CITY OF GLENDALE, CA

DESIGN REVIEW STAFF REPORT – SINGLE FAMILY

1170 N Kenilworth Avenue

PADR-002378-2023

SHEET TITLE:
ELEVATIONS

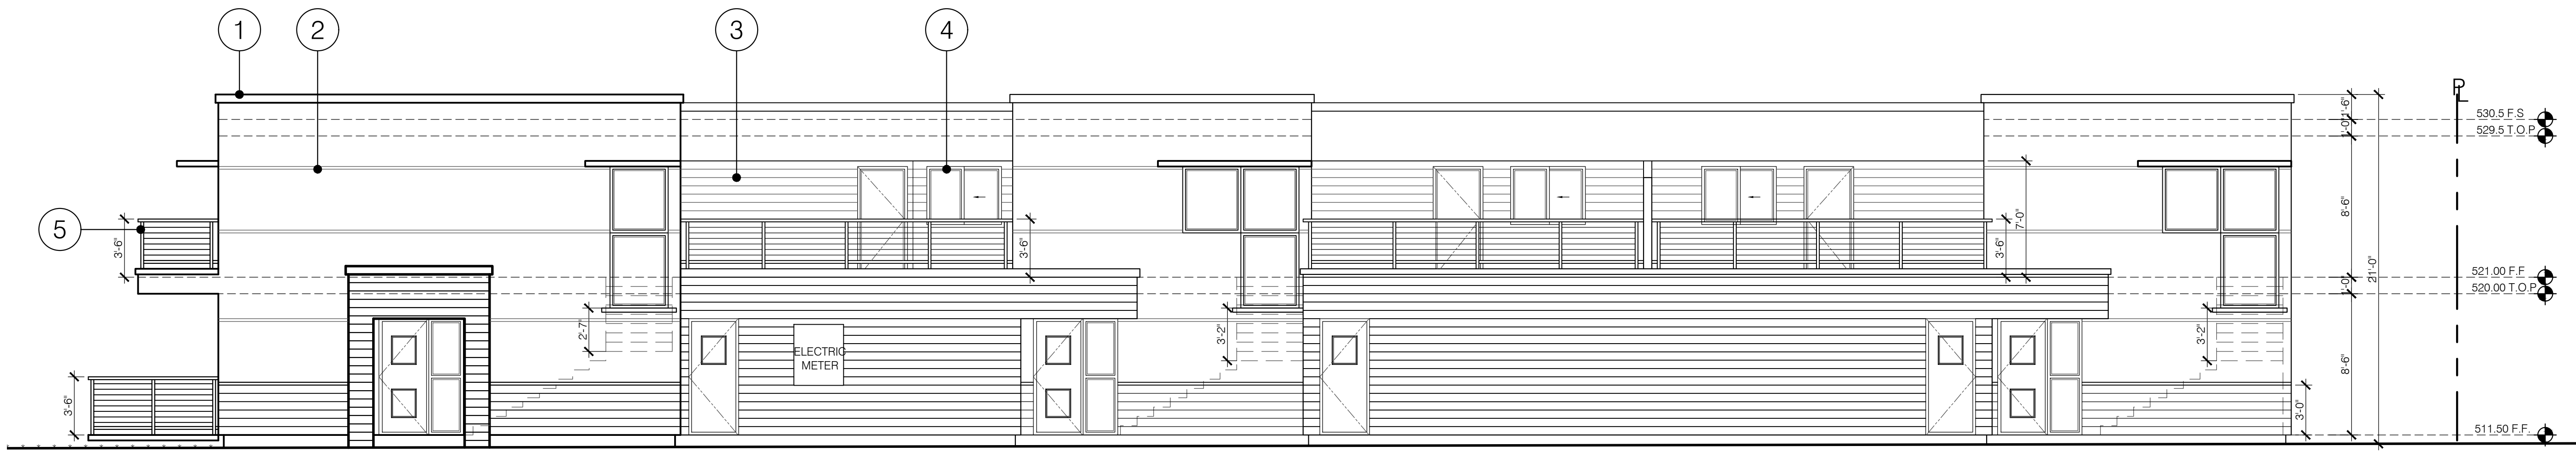
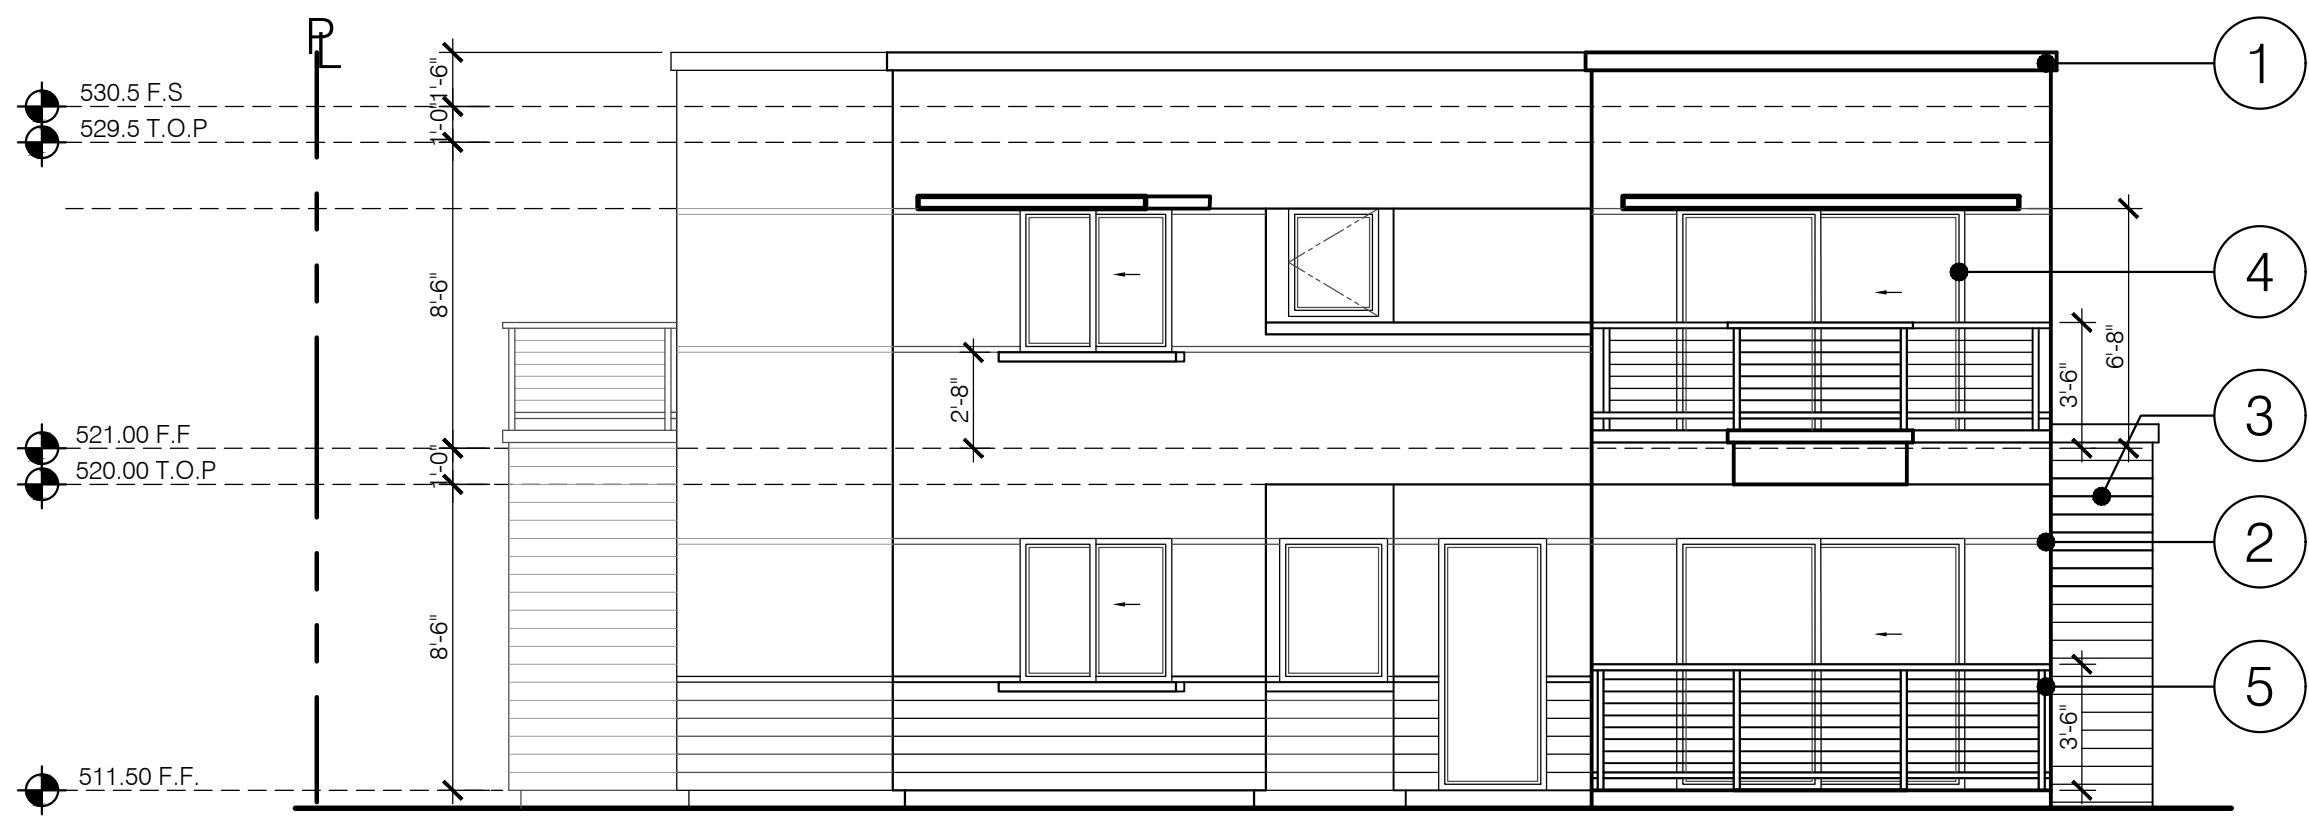
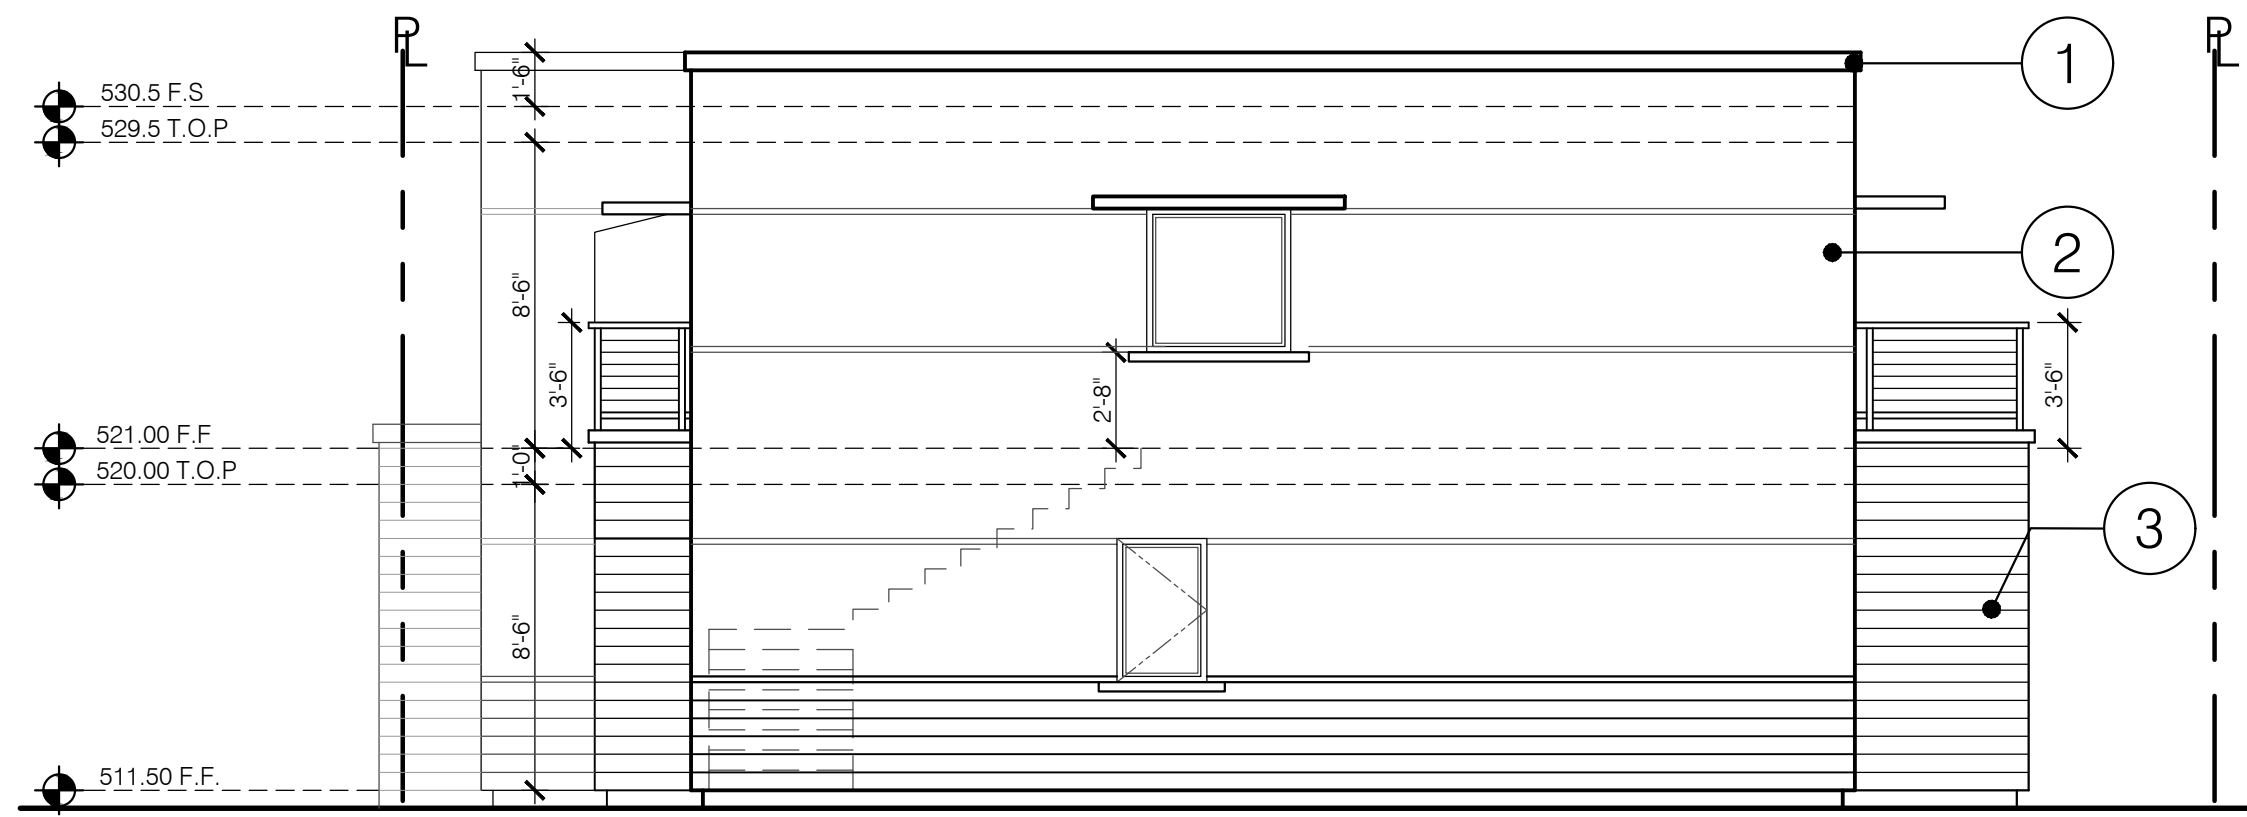
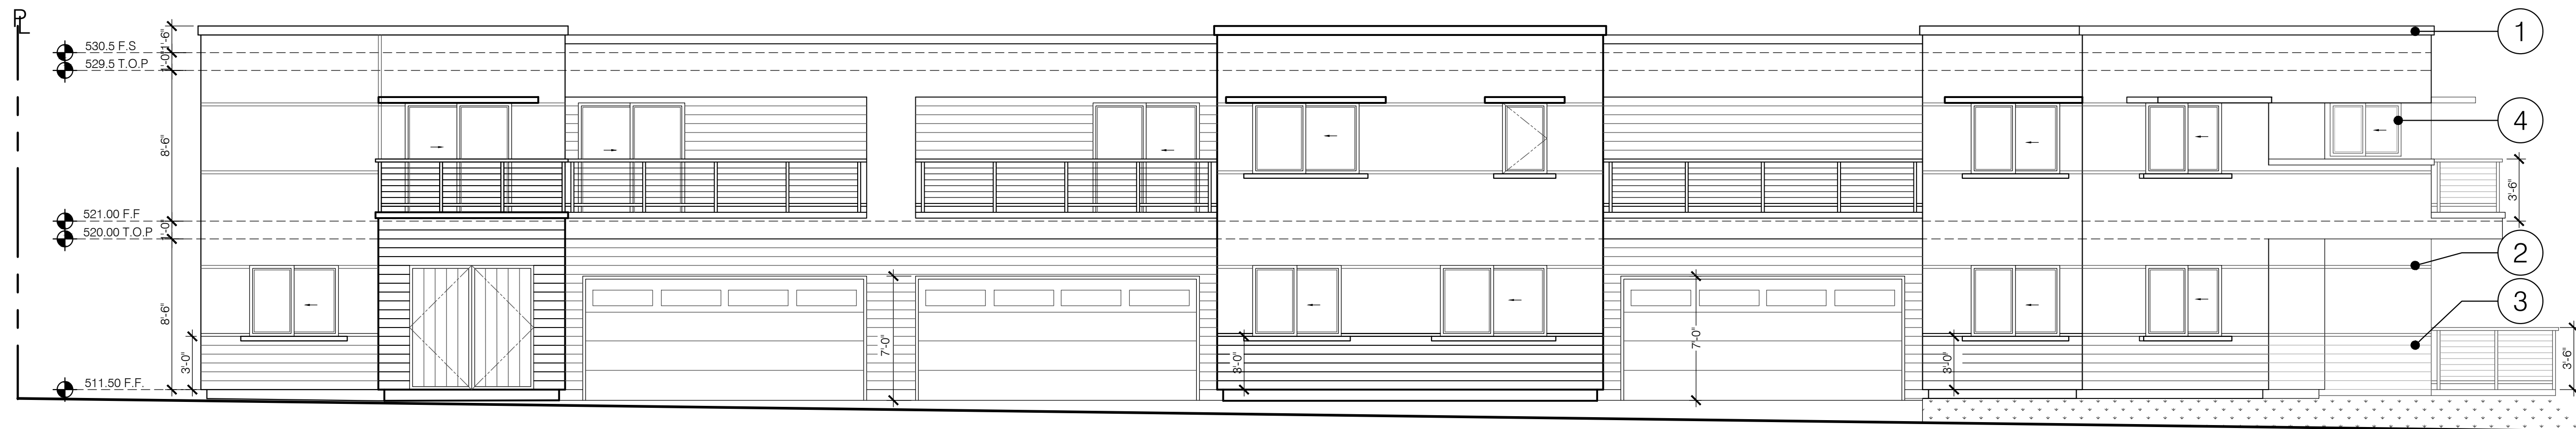
The applicant has selected vinyl block frame windows, which are appropriate to the style of the building. However, several of the proposed windows are sliders and will be

visible from the street. To better enhance the design of the building, a condition is included to replace the slider windows with casement, hung, or fixed.

- The applicant has selected vinyl block frame windows, which are appropriate to the style of the building. However, several of the proposed windows are sliders and will be visible from the street. A condition has been included to revise the sliders to an option more appropriate, such as casement, hung, or fixed.

1. Replace the sliding windows with casement, hung or fixed type window and show this information on the window schedule and elevation drawings.
2. Revise drawings to show decorative driveway material and include this information on the site plan.
3. Show the location of all proposed site lighting and light fixtures on the building limited to the main entry and patio doors.
4. Show downspouts on the building, finished to match the adjacent wall color.
